SUBJECT: NuScale Power, LLC Supplemental Response to NRC Request for Additional Information No. 401 (eRAI No. 9447) on the NuScale Design Certification Application

NuScale Supplemental Response to NRC Request for Additional Information eRAI No. 9447

NRC Question No.: 03.11-19

Figure 3.7.3-4a: In-Structure Response Spectra at the Bioshield in X-Direction for Nodes 25826 and 26345 and the Enveloped ISRS using 4% Damping

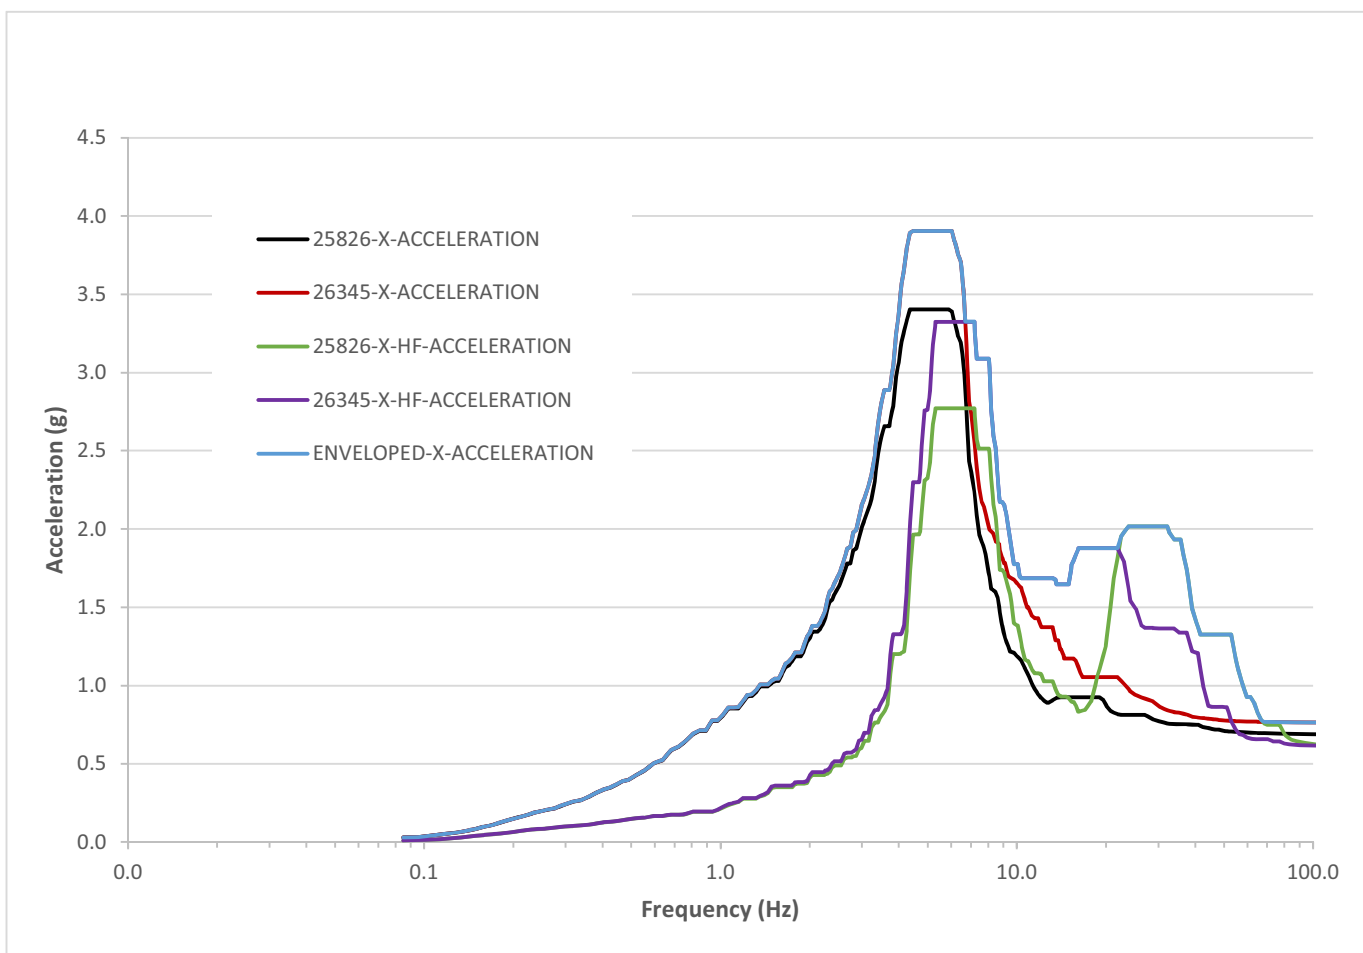
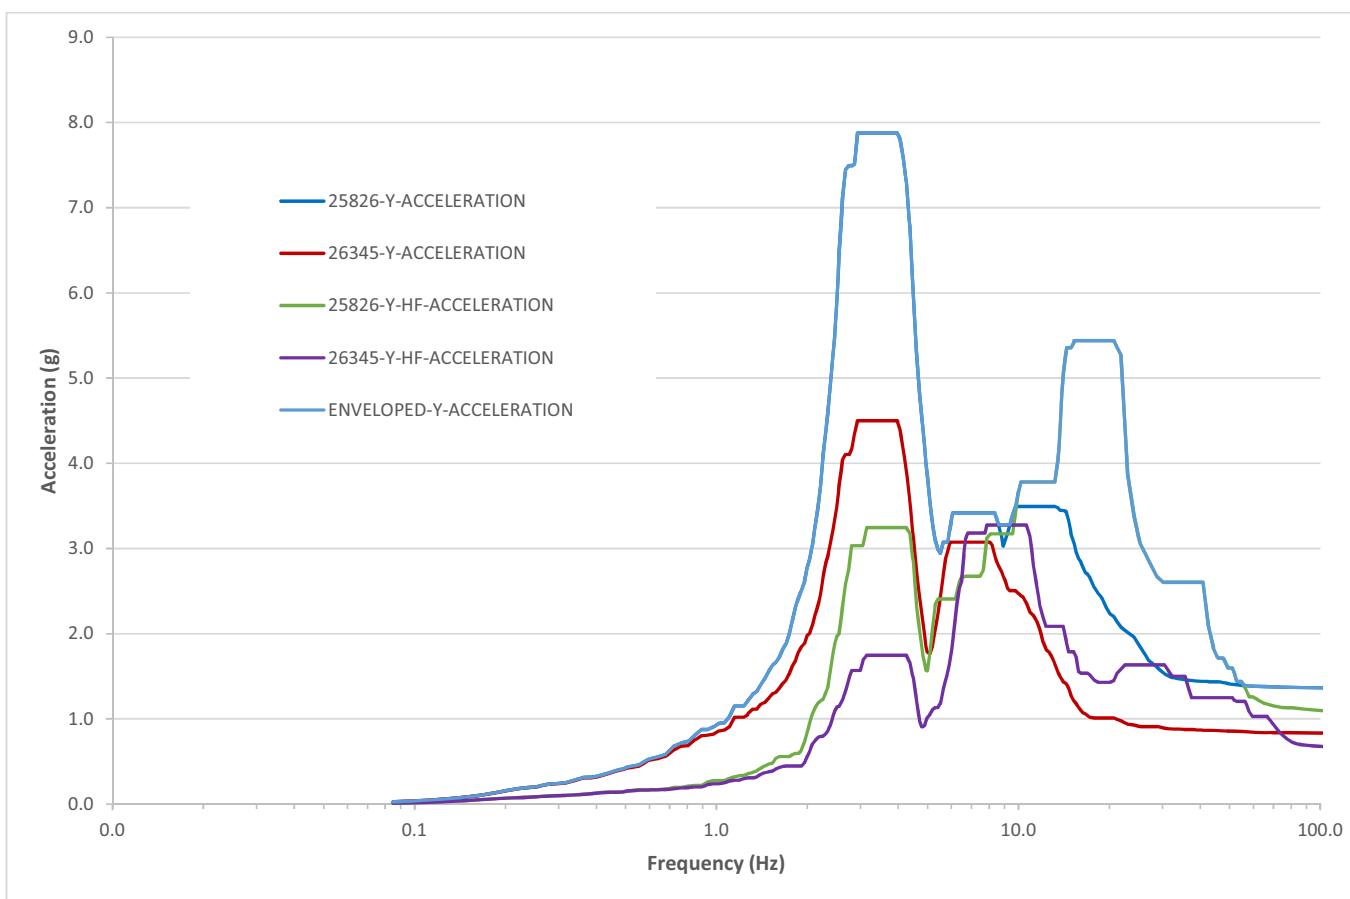
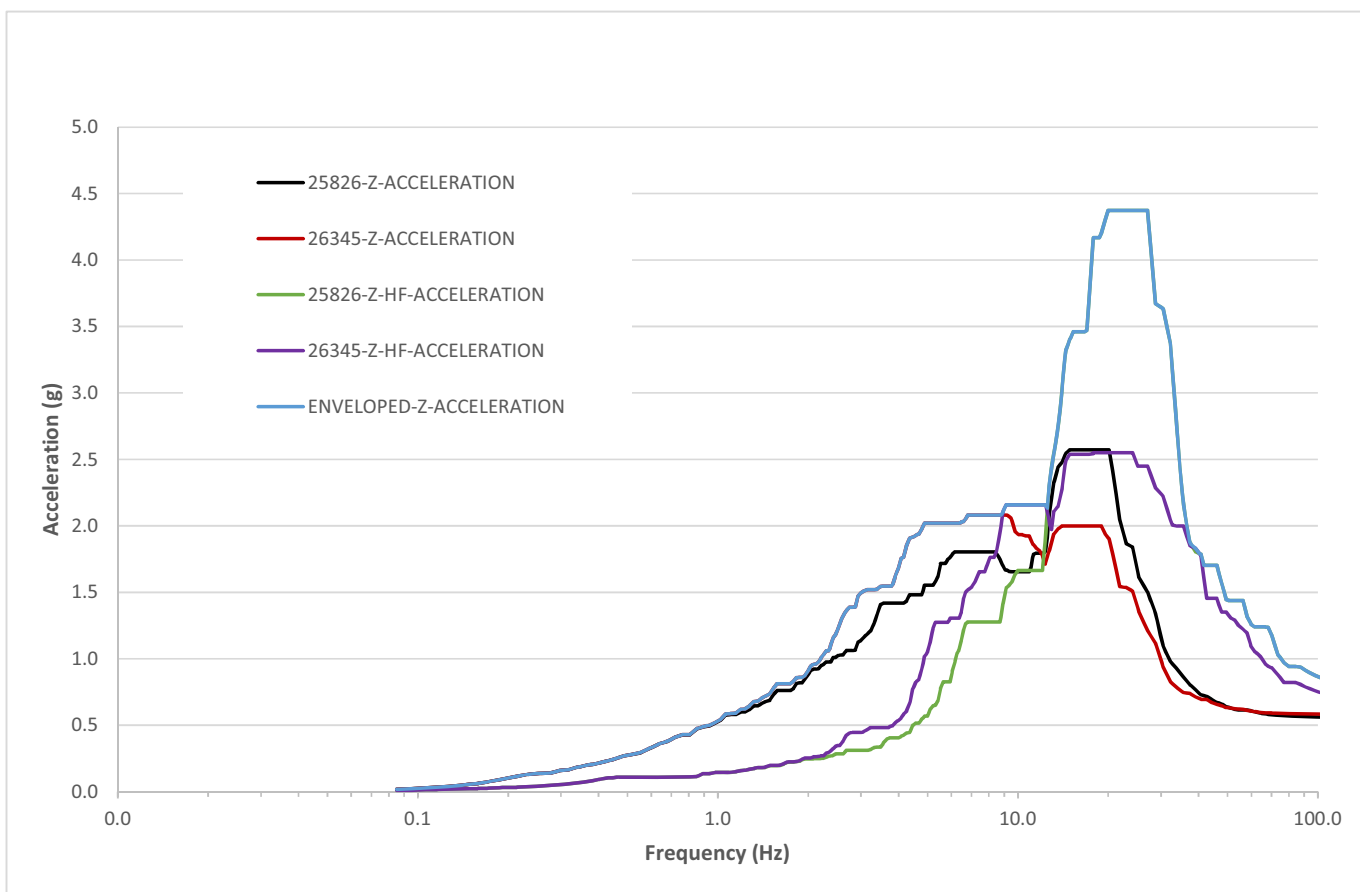
In-structure response spectra were developed for multiple locations in the RXB in Section 3.7.2. Two nodes from that model were selected to use for the design of bioshields. These nodes are shown in Figure 3.7.3-3. Plots of the ISRS with 4 percent damping at these nodes are shown in ~~Figure 3.7.3-4~~ Figure 3.7.3-4a through Figure 3.7.3-4c. These figures envelop CSDRS and CSDRS-HF curves and include the

The structural analysis and design of the horizontal slab and vertical assembly was performed by generating two sets of SAP2000 finite element models. A time history analysis is performed for both model sets. The time histories are based on the synthetic time histories that were matched to the corresponding 4-percent ISRS in the same direction given in Figure 3.7.3-4a through Figure 3.7.3-4c.

Figure 3C-3: Bounding Envelope for Average Vapor Temperature at Top of Module (Zone G)

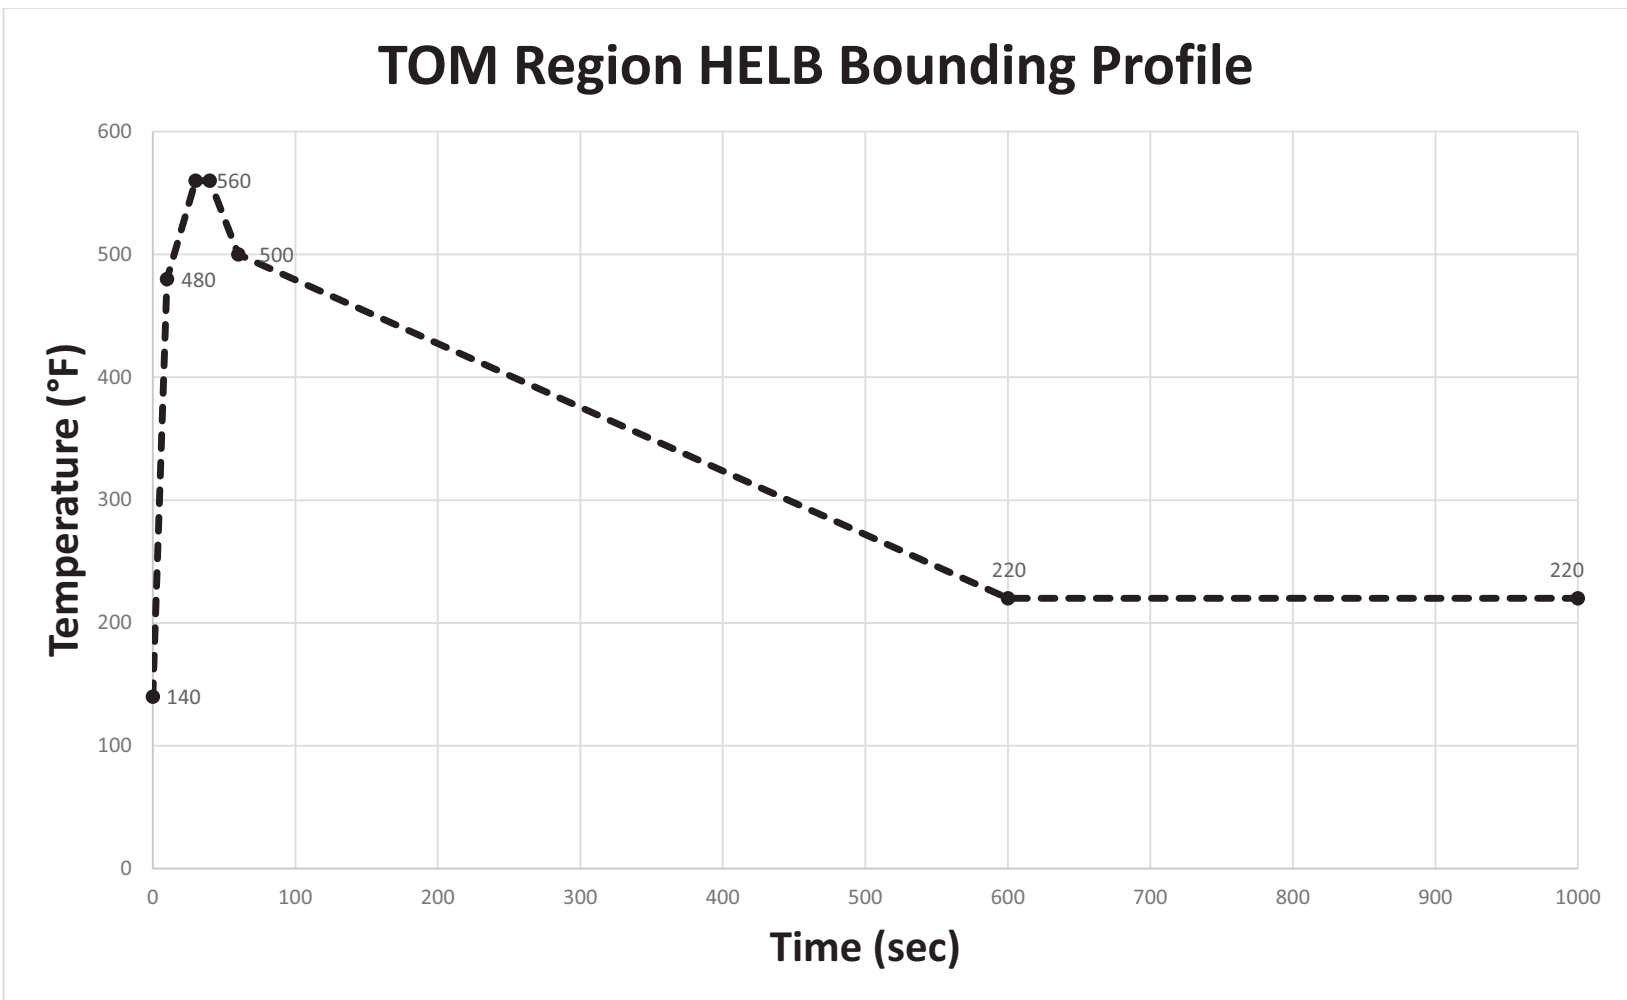
NuScale's FSAR Chapter 3 describes that the environmental conditions of design basis accidents under the bioshield are established assuming a vented bioshield (Appendix 3C and Figure 3C-3). In a response to RAI 9160, the applicant describes that the bioshield relieves (i.e., vents) the high pressure and temperature environment under the bioshield by opening relief panels. The panels are required to change position from normally closed to open in order to vent the atmosphere under the bioshield into the reactor building. The panels are hinged and provide one-way relief (venting) in response to a HELB under the bioshield.

RPV and containment vessel metal temperatures in the lower (liquid) space with corresponding liquid temperatures for the bounding DBAs are shown on Figure 3C-1. RPV and containment vessel metal temperatures in the upper (vapor) space with corresponding vapor temperatures for the bounding DBAs are shown on Figure 3C-2. The average vapor temperatures at the top of module for the bounding DBAs, and assuming a vented bioshield, are shown on Figure 3C-3. Refer to Section 3.7.3 for a description of the bioshield. The maximum vapor temperatures for elevation 145' in the RXB from the same bounding DBAs are shown on Figure 3C-4.
